**PLANNED UNIT DEVELOPMENT &
SUBDIVISION STAFF REPORT****Date: October 6, 2005****DEVELOPMENT NAME**

Louise Place Subdivision, Unit 2

APPLICATION NUMBER 1 & 2 DATE October 6, 2005
APPLICANT Louise Place Subdivision, Unit Two
REQUEST Planned Unit Development, Subdivision

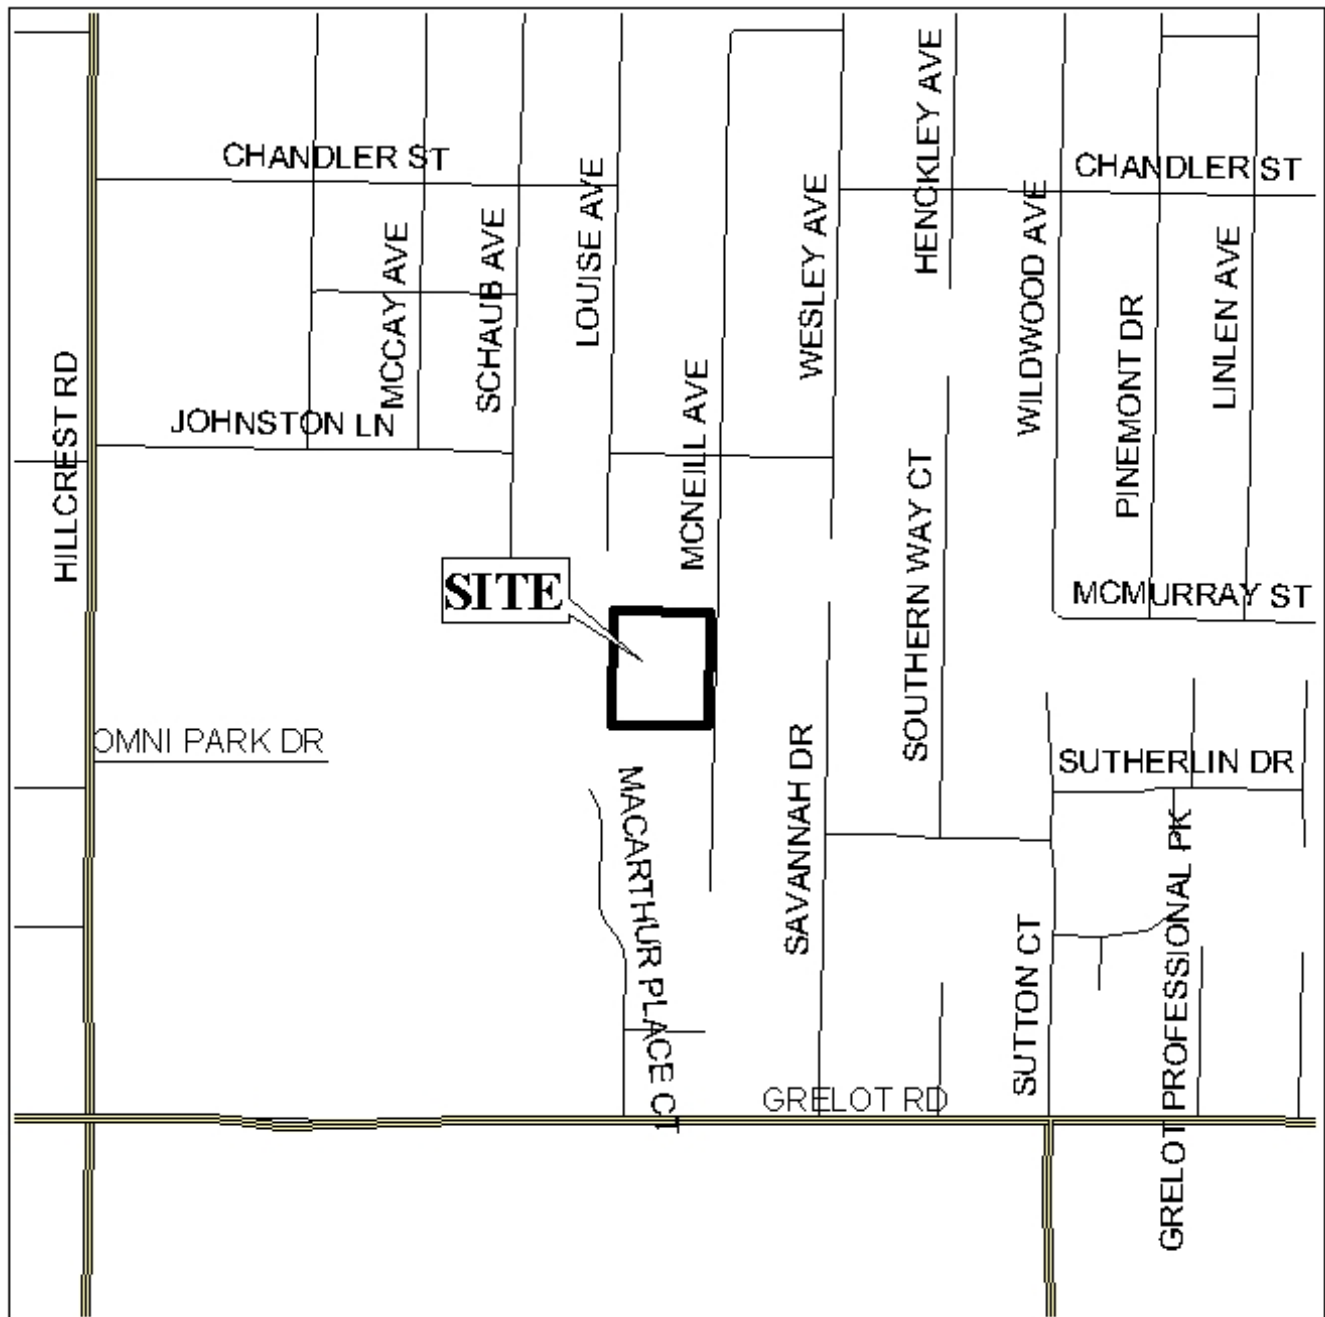
Attention should be called to two situations with the proposed site. First, the site plan shows the entirety of Gulver Street being vacated to the proposed subdivision; however, half of the vacated right-of-way should be conferred to the southern neighbors. If the southern neighbors do not transfer their portion of the right-of-way to the applicant, this would leave proposed Lot 10 with only 30 feet of width, which would be unacceptable.

Thus, if the applicant is unable to acquire the southern half of the vacated Gulver Street right-of-way, the plat should be reconfigured to eliminate proposed Lot 10.

The second issue is the shape of proposed Lot 2, which is wide along the street frontage and narrows toward the rear, where it is 37 feet wide. This is atypical of lots on any cul-de-sac, which typically start narrow and widen toward the rear, and of this neighborhood in particular. To satisfy Section V.D.1 of the Subdivision Regulations, which states “*the shape [of lots]... shall be appropriate to the location of the subdivision*”, the side lot lines should either be approximately parallel, or should widen toward the rear of the lot, or the applicant should demonstrate a physical reason for the atypical shape. Proposed Lot 3 to the east, at approximately 9800 square feet, would not be harmed by such an adjustment.

Based on the preceding, this application is recommended for Holdover, to allow the applicant to submit revised drawings depicting a common area with adequate detention; and to revise the configuration of proposed Lot 2 so that the rear is not appreciably narrower than the front.
